**From:** [Bista, Shabnam](#)  
**To:** [Laura Kaplan](#)  
**Cc:** [boulderplanningboard](#)  
**Subject:** RE: CALL UP ADDED: 05.26.2022 PB Packet is Ready  
**Date:** Wednesday, May 25, 2022 5:52:20 PM  
**Attachments:** [image001.png](#)  
[image002.png](#)

**From:** [Ferro, Charles](#)  
**To:** [Sarah Silver](#)  
**Cc:** [boulderplanningboard](#); [Bista, Shabnam](#)  
**Subject:** RE: A few clarifying questions re: Call Up/LUR2020-00061  
**Date:** Wednesday, May 25, 2022 5:18:51 PM

**From:** [Ferro, Charles](#)  
**To:** [boulderplanningboard](#)  
**Cc:** [Walbert, Sloane](#)  
**Subject:** FW: 5-26-22 Agenda Item 4A  
**Date:** Wednesday, May 25, 2022 2:32:11 PM  
**Attachments:** [Responses.pdf](#)

Responses to Questions in Email dated 5/23/22

SIDE PLAN

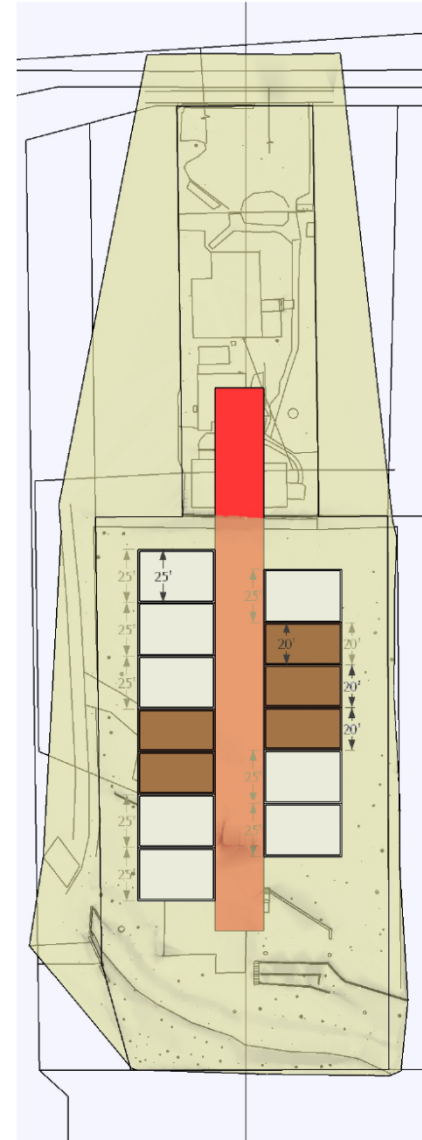
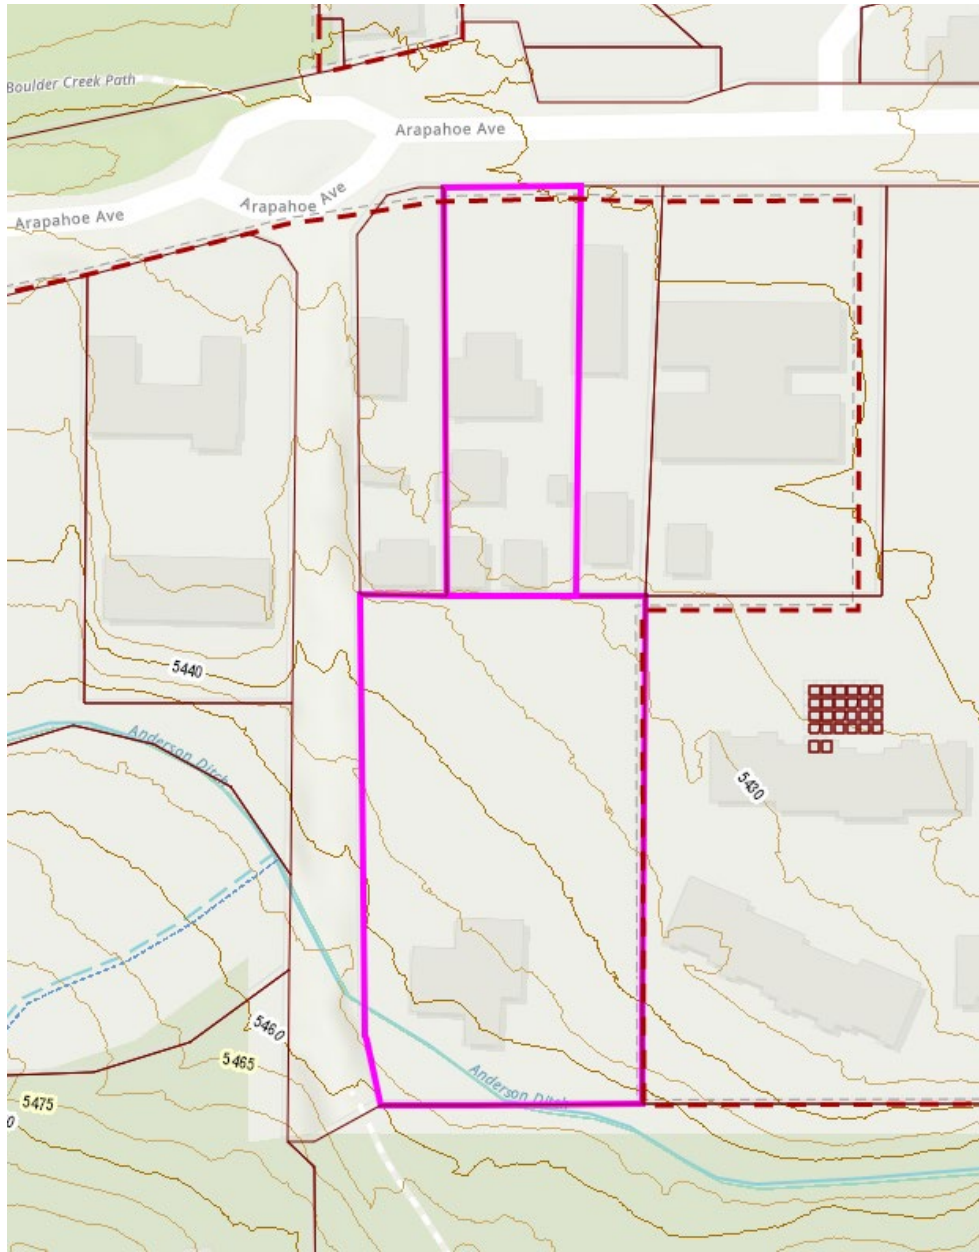
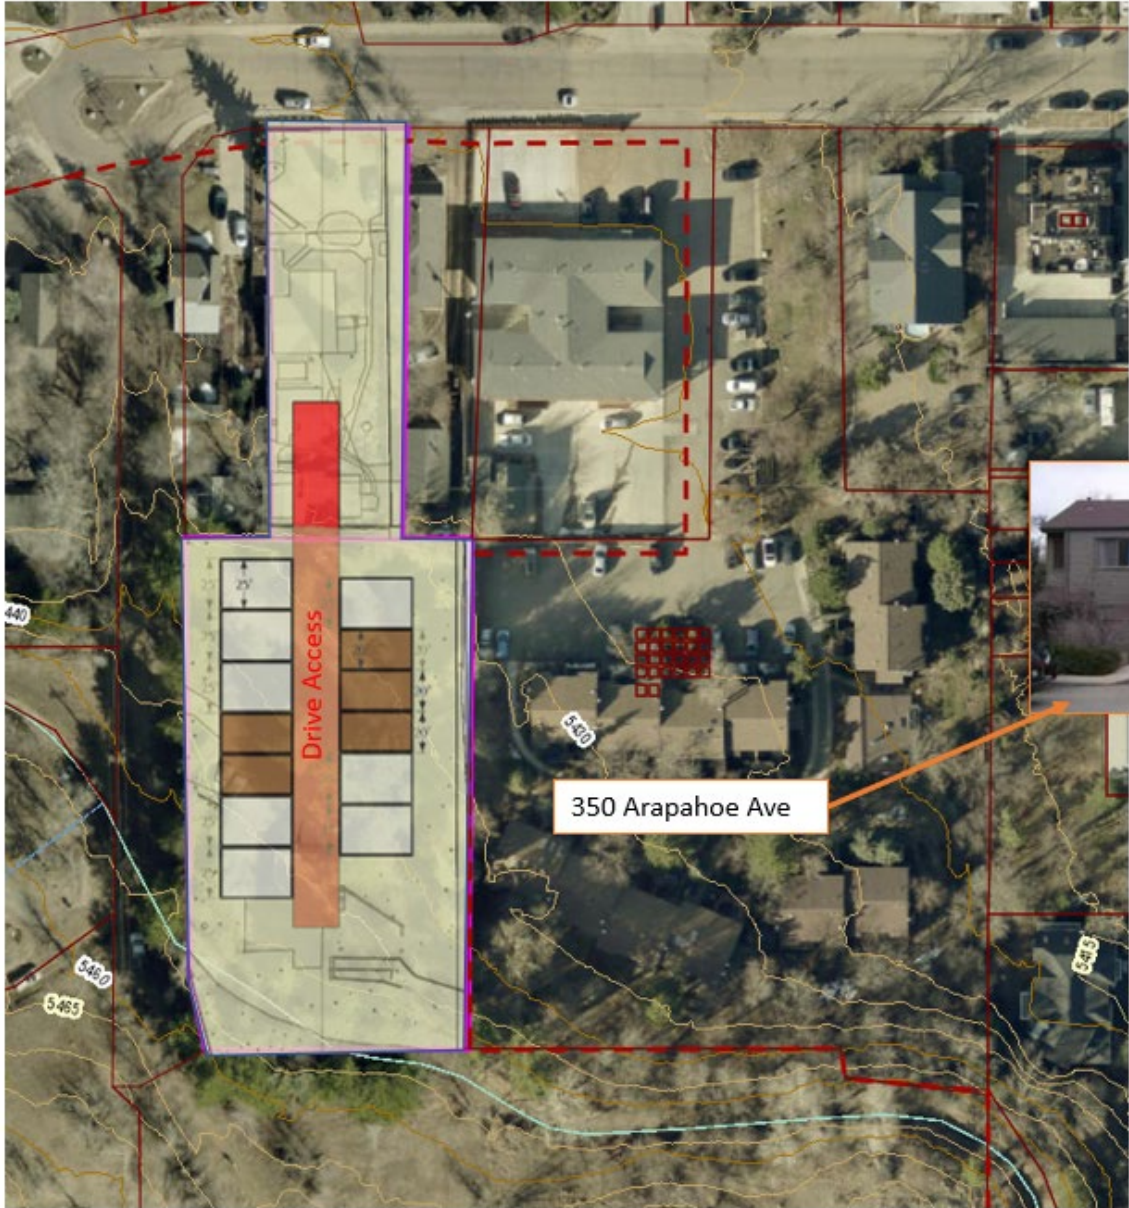
**Isn't the sketch showing the housing developed on the steepest and most vegetated part of the site?** The development is not proposed to be concentrated on Arapahoe but rather on the upper parcel, **is this not correct?**

**The conceptual plans show the buildings out of the steep slopes that lead up to the ditch on the far south end of the site. See graphics below. The proposed development appears to be consistent in orientation and mass/scale with developments in the vicinity, like the adjacent site at 350 Arapahoe Ave. The applicant is limited to taking access and bringing utilities from Arapahoe Ave. There are maximum slopes for drive access lanes and limitations in bringing utilities up the slope, which will ensure the development is not constructed too far up the slope. However, it does appear that a few mature trees would be removed in this scenario.**

**Regarding grading, refer to the conceptual site section, which shows some modifications to the grade. It appears that the building would step up with the slope to avoid extensive grading and large retaining walls.**
